Log ~~2550~~  
**National Transportation Safety Board**

Washington, D.C. 20594  
**Safety Recommendation**

Date: July 3, 1995  
In reply refer to : A-95-68 through -70

**FIGURE 1. MAIN LANDING GEAR SHIMMY DAMPER ASSEMBLY**

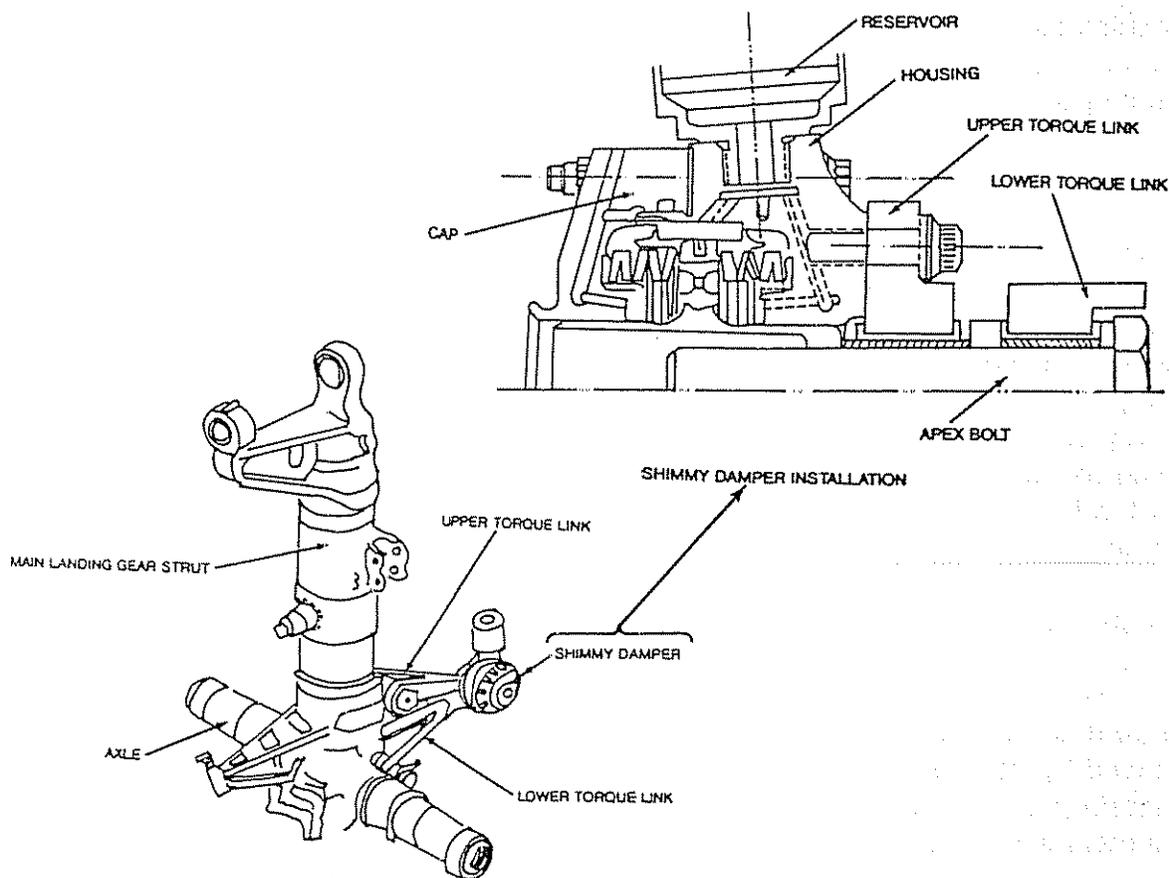
The McDonnell Douglas MD-80 and earlier DC-9 series airplanes are configured with shimmy dampers, which provide torsional/lateral vibrational stability to the landing gear during the landing roll (see Figure 1). The upper torque link is connected to the main stationary strut, and the lower torque link is connected to the compressible strut. Both the upper and lower torque links are connected to a shimmy damper with a single apex bolt. The upper torque link remains stationary, and the lower torque link moves laterally along with the apex bolt to provide a lateral damping movement.

The Safety Board notes that the shimmy dampers on the MD-80 and earlier DC-9 models are similar in design and function. Due to this similarity, the Safety Board believes that any change in design or modification made to the shimmy dampers of the MD-80 may also be appropriate to the shimmy dampers installed in earlier DC-9 series airplanes. The Safety Board recognizes that the landing/takeoff weight, speeds, and other factors/issues need to be considered before effecting any change to the design of the DC-9 series airplane's shimmy damper, and therefore believes that the FAA should, in conjunction with the DAC, evaluate whether implementing design changes or modifications to earlier model DC-9 series airplanes' shimmy dampers, as specified in SBs A32-275 and 32-278 for MD-80 series airplanes, would be appropriate.

In conjunction with the Douglas Aircraft Company (DAC), evaluate the possibility of implementing modifications to DC-9-10, -20, -30, -40 and -50 series airplane shimmy dampers as specified in the DAC's SBs A32-275 and 32-278 for the MD-80 series airplane to enhance the performance of the shimmy damper and to reduce the potential for landing gear vibration and failure during the landing roll. (Class II, Priority Action)(A-95-69)
